PLANNING COMMISSION AGENDA

Tuesday, September 15, 2015
Breckenridge Council Chambers
150 Ski Hill Road

Planning Commission Staff Report

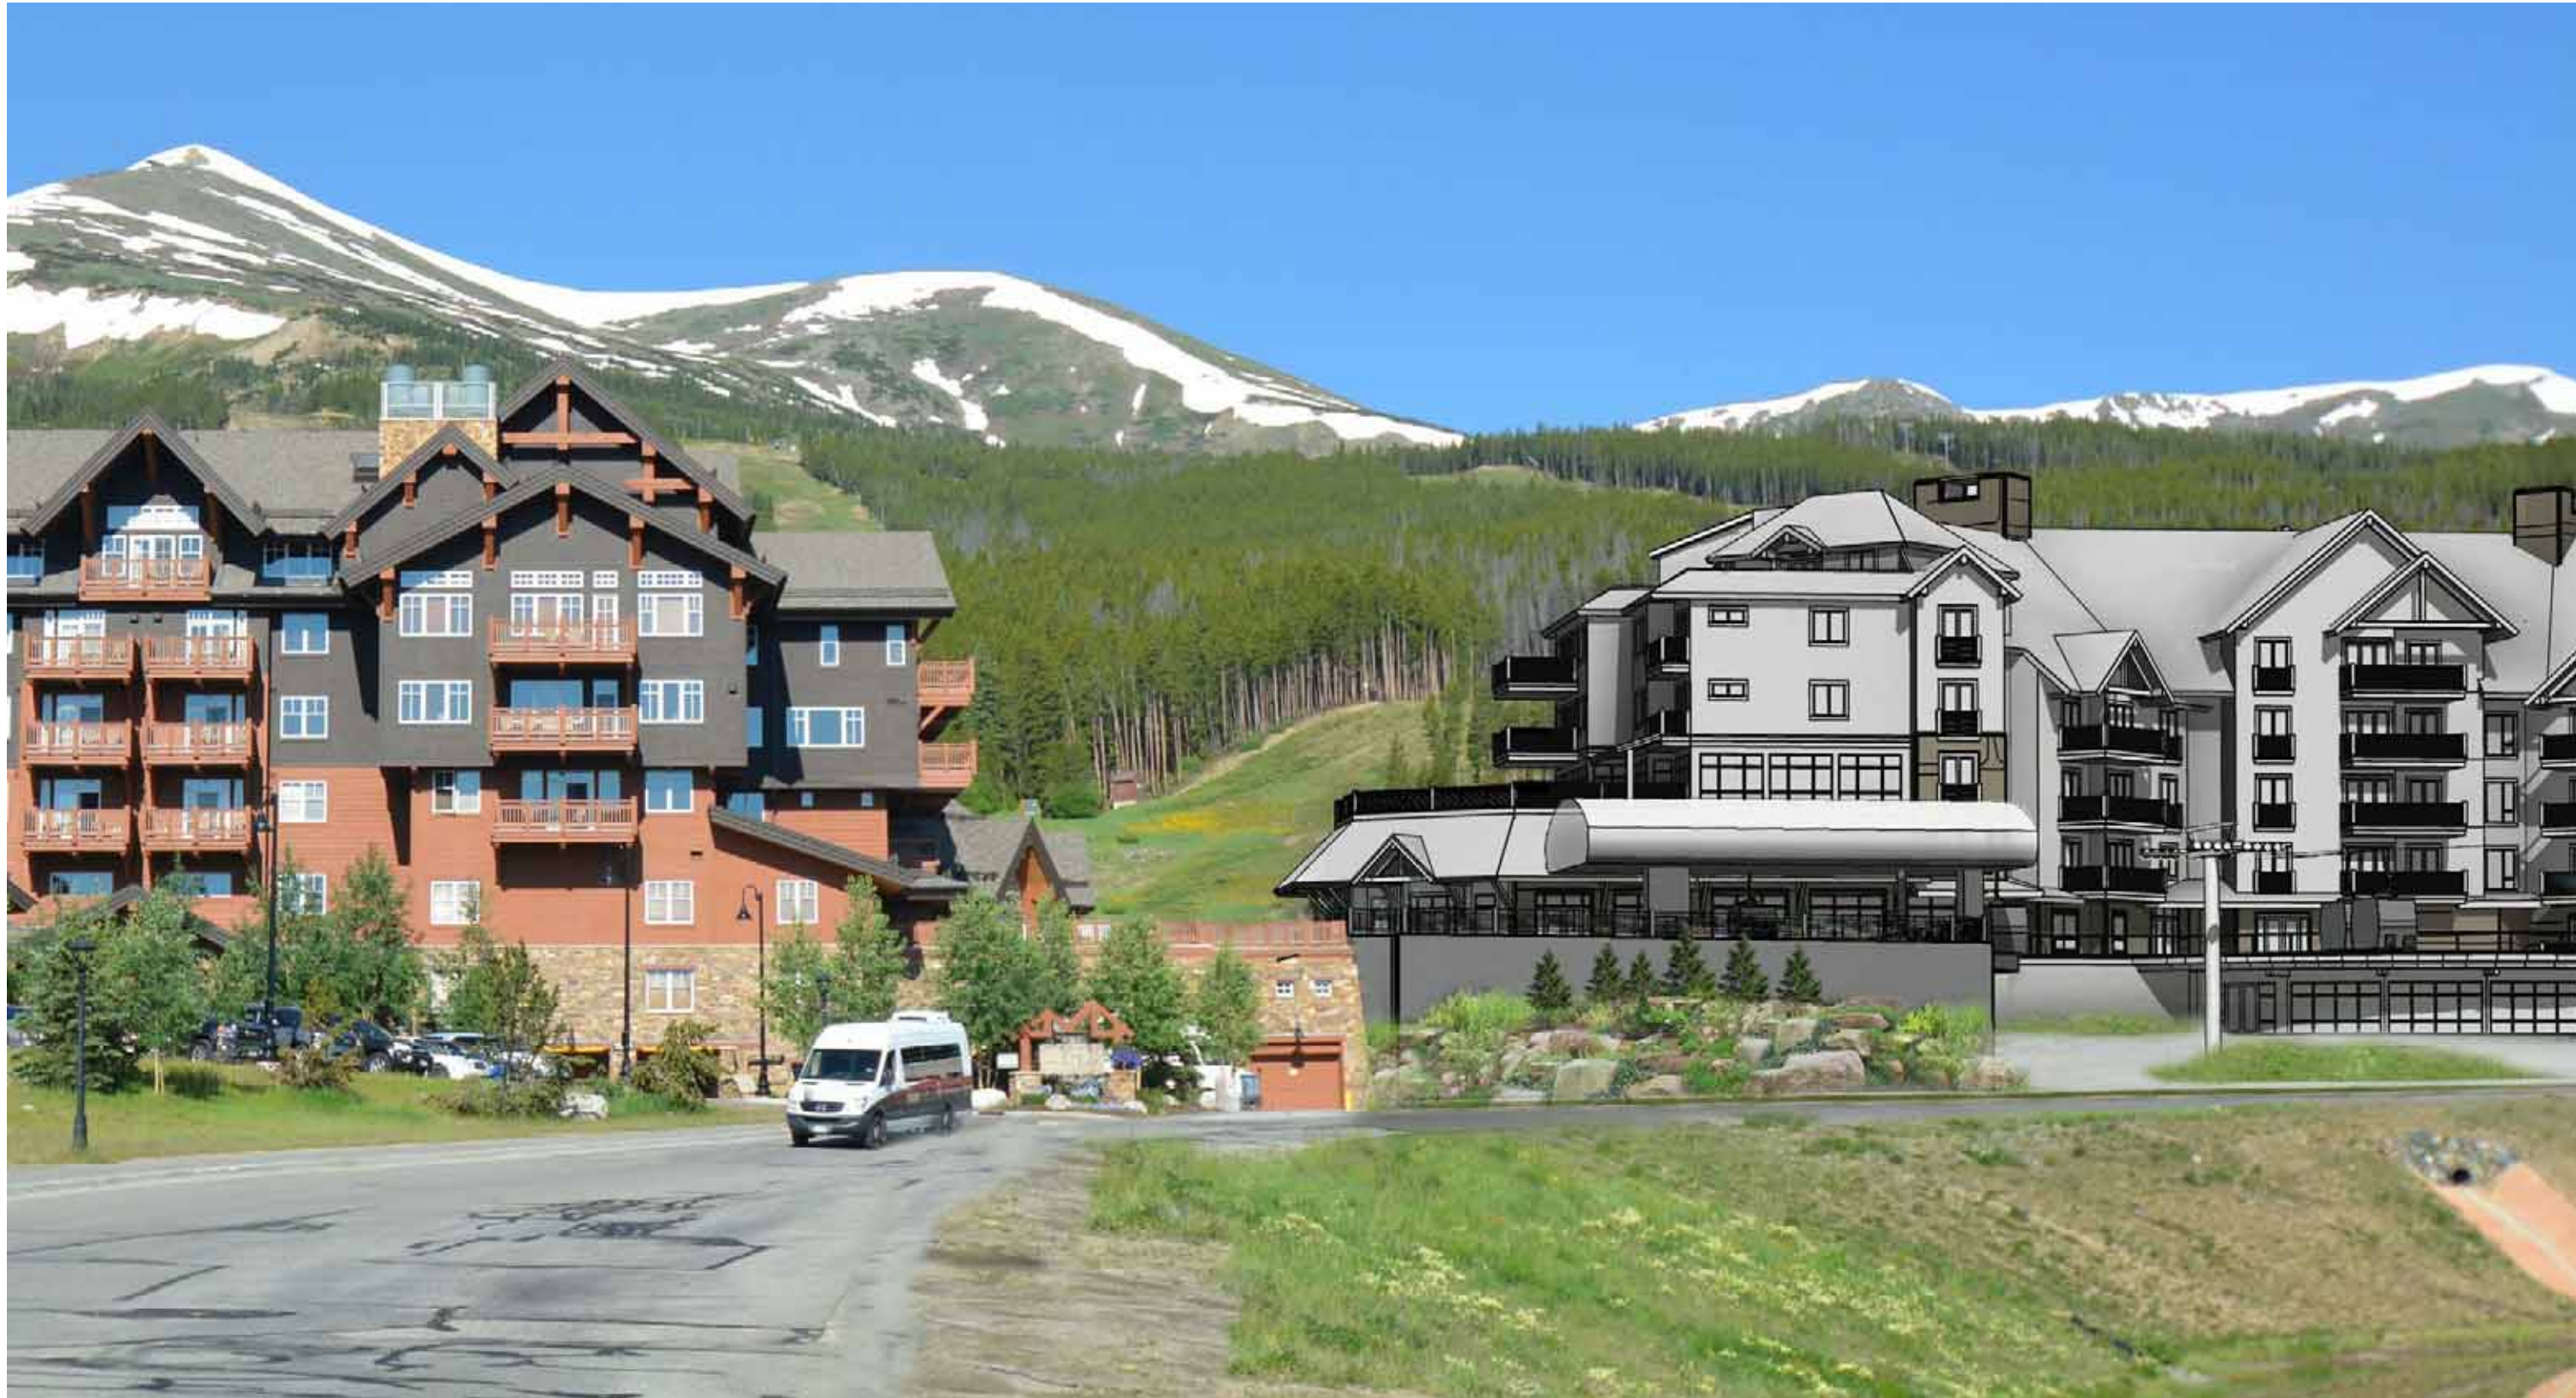
The finished grade as described in the Master Plan is shown on Sheet A109. The original Peak 7&8 Master Plan (and this provision is still part of the Master Plan) allowed for the applicant to establish natural grade at the base of Peak 8 since Ski Hill Road, the parking lots, driveways and the Bergenhof were placed into the natural hillside destroying the natural slope with new cut and fill.
